Title: Advisory Committee on Reactor Safeguards
 Subcommittee on the Westinghouse AP1000
 DCD and AP1000 RCOL: Open Session

Date: Tuesday, September 21, 2010

Water Drainage/Corrosion Issue Discussion	4
DCD Chapter 5 - Applicant	24
Upcoming ACRS Interactions	68

Reactor Coolant Pump Flywheel Analysis

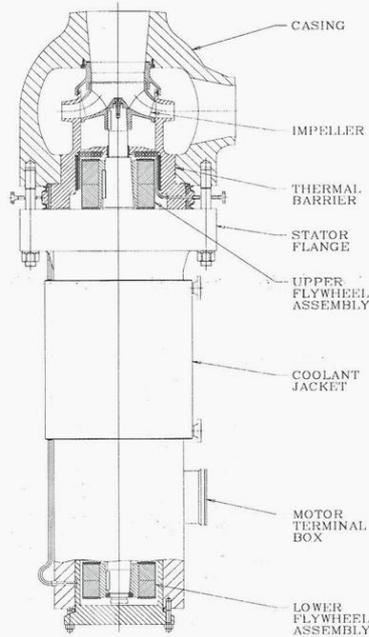
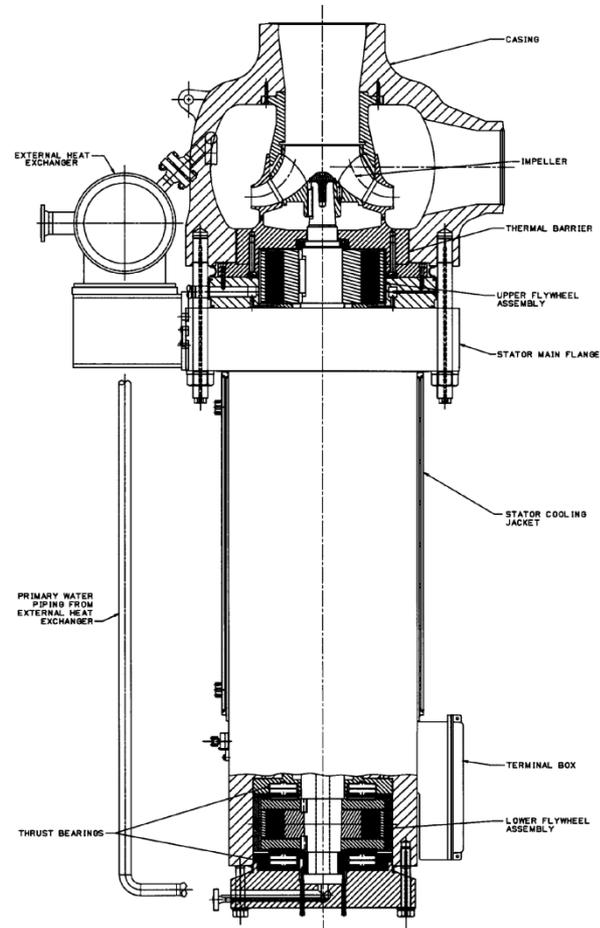
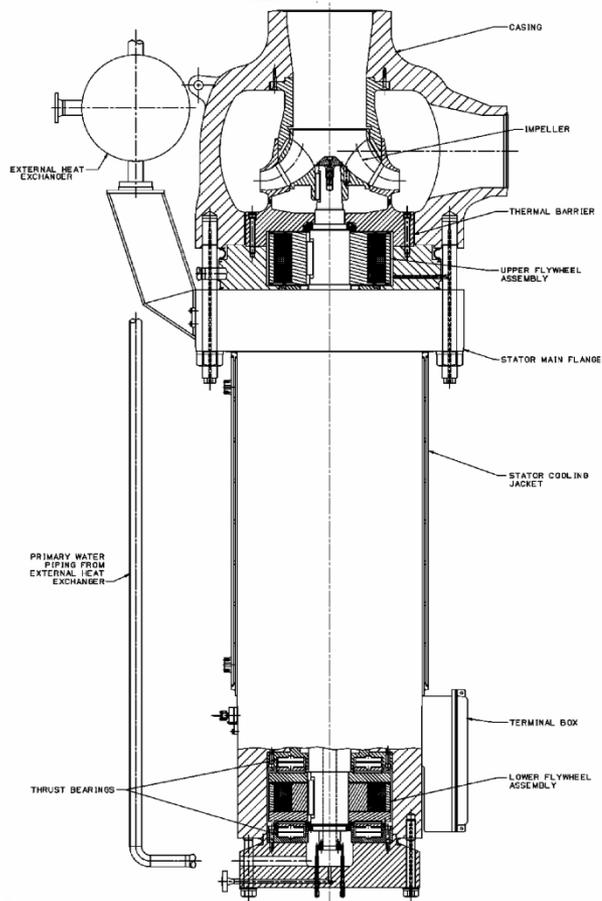
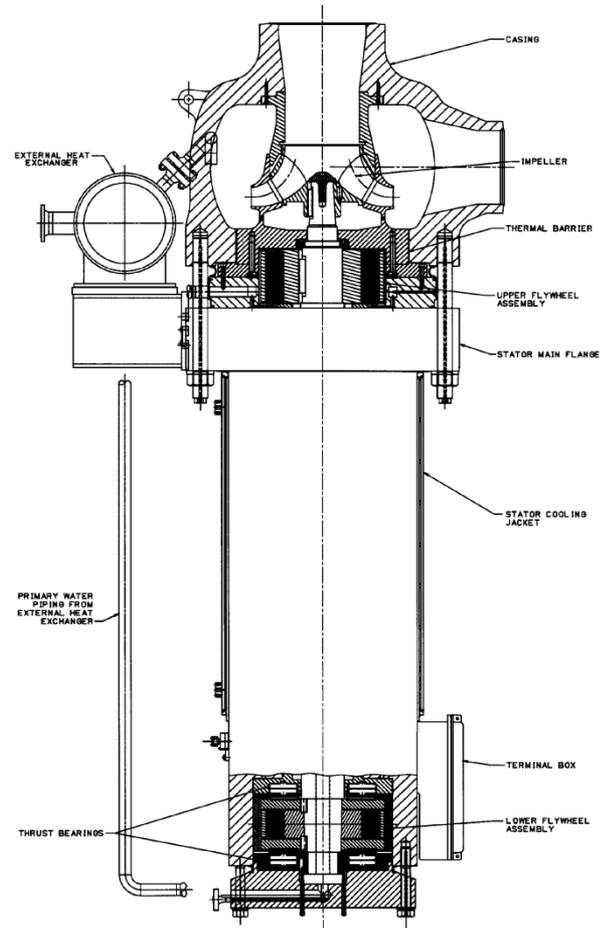
15 MR. HONCHARIK: But now in the current
16 version, as you can see, around the upper flywheel,
17 you see that there is a retaining -- see there is a
18 little terminology that is called a retainer ring on
19 the flywheel but also there is a retaining ring that
20 is attached to the pump casing that holds in the
21 flywheel and then there is also -- also they added the
22 stator closure ring and the stator closure and
23 actually that is called a thermal barrier I'm sorry,
24 that goes around the flywheel.

1 there now where previously there was one. Let's go to
2 the next slide. And this just shows kind of what
3 happened in Rev. 16 where they had the thermal barrier
4 but they added that lower portion which was the stator
5 ring. Where it is now, it has three pieces.

- Open Item
 - Include flywheel materials used in flywheel analysis in DCD.
- Prior to proposing to include the flywheel materials in the DCD, Westinghouse proposed a material change to RCP flywheel outer hub, and other changes that may impact the flywheel analysis.
- The following will discuss these changes.

- Previous Flywheel Materials:
 - Heavy tungsten inserts with Type 403 Stainless steel inner hub and 18-Ni maraging steel outer hub.
 - Alloy 625 outer shell
 - Flywheel analysis performed for the above materials
- Proposed Material Change:
 - 18Mn 18Cr alloy Steel (ASTM A 289, Grade 8) outer hub
- Proposed 18Mn 18Cr material not included in flywheel analysis.
- Therefore, need to demonstrate flywheel does not generate a missile.

RCPB Materials - Quickloc

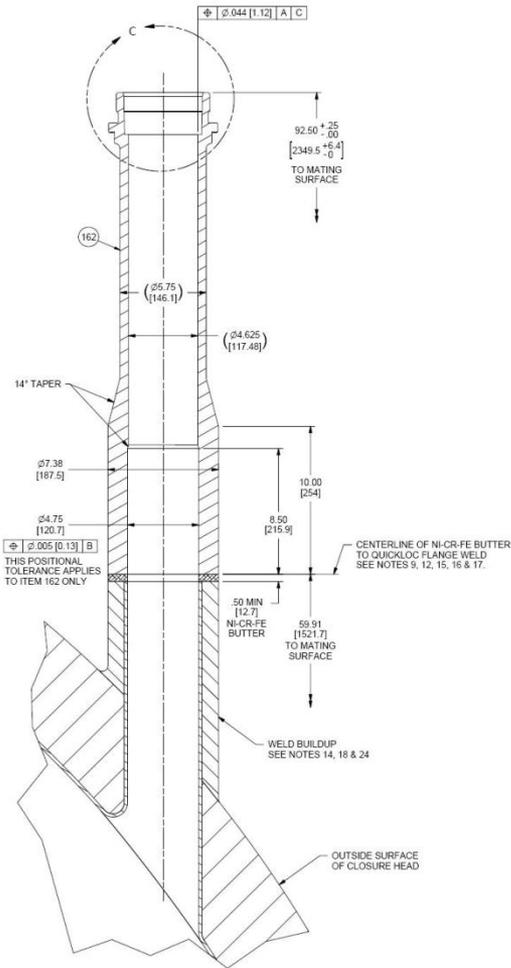
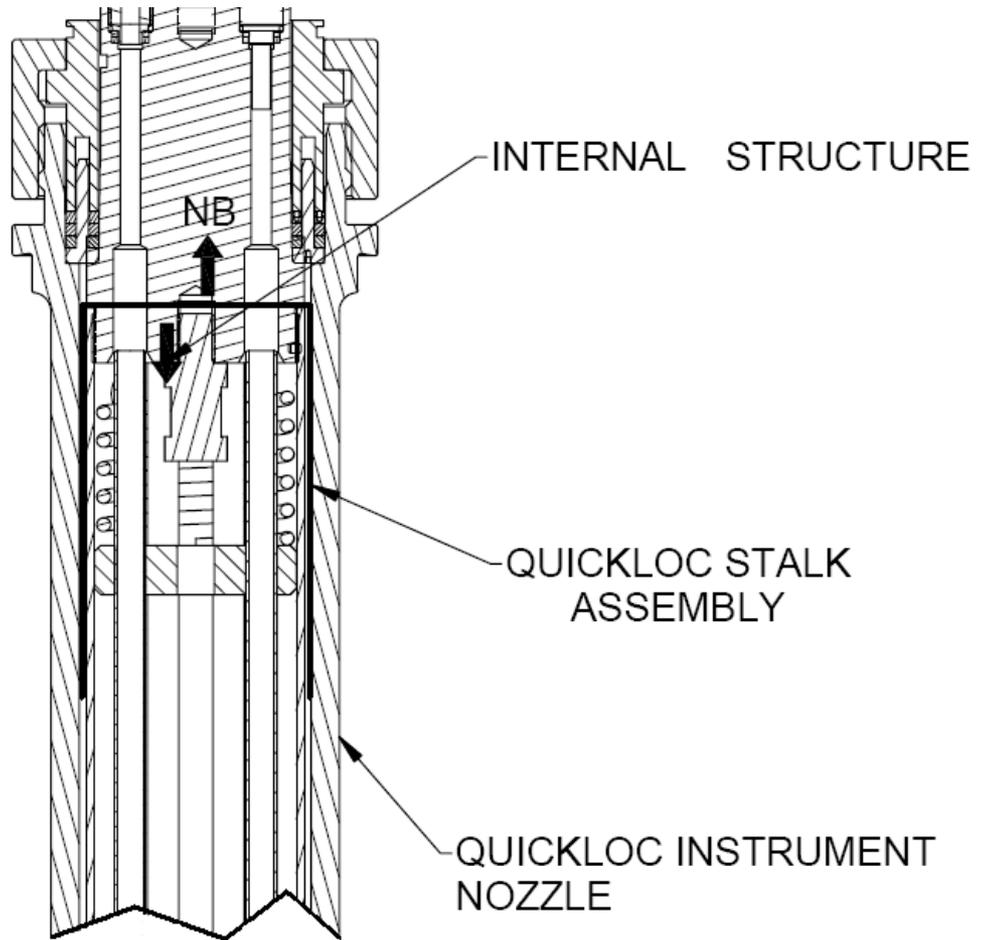
- RAI
 - Staff requested that Westinghouse discuss the QuickLoc component specified in AP1000 DCD, FSAR Figure 5.3-1. Provide a summary of this information in the DCD.

5 So after the discussion with Westinghouse
6 it was decided that a OL action item would be added to
7 the AP1000 DCD and this item would state that COL
8 would hold a 100 percent volumetric inspection every
9 10 years of this weld build up in accordance with
10 Section 11 of ASME code, using acceptance criteria.

RCPB Materials - Quickloc

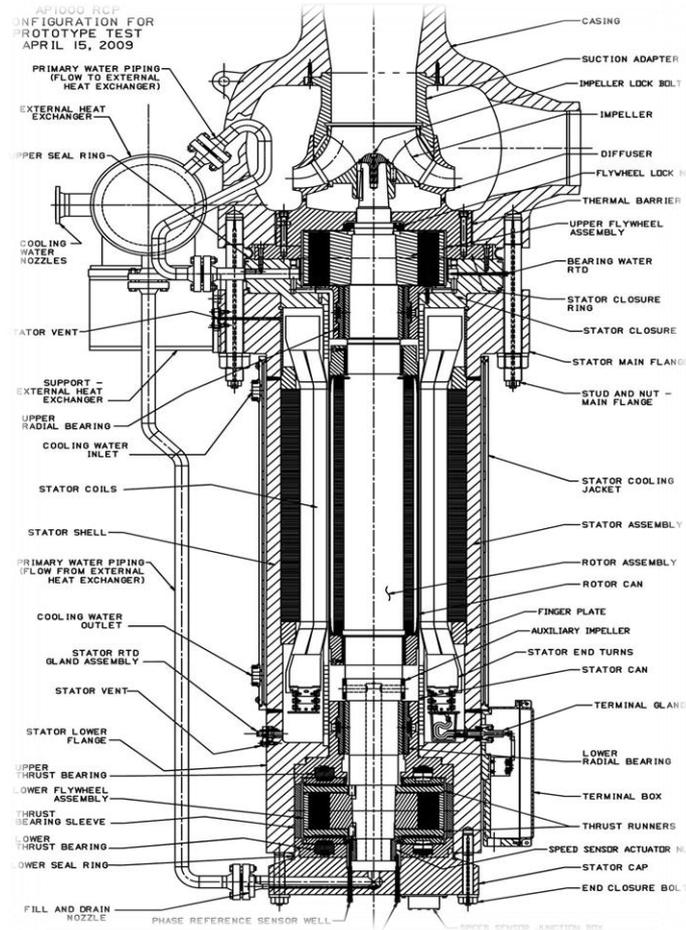
- Staff did not agree with the proposal that the weld buildup of the Quickloc nozzle (which forms the reactor coolant pressure boundary) did not require future inservice inspections to be performed.
- NRC staff were concerned about ensuring the integrity of the weld buildup during the service.
- Based on the staff's concern, Westinghouse proposed a COL action item which would specify that the COL holder would include a 100% volumetric examination of the weld buildup every ten years using the acceptance criteria in ASME Code, Section XI.
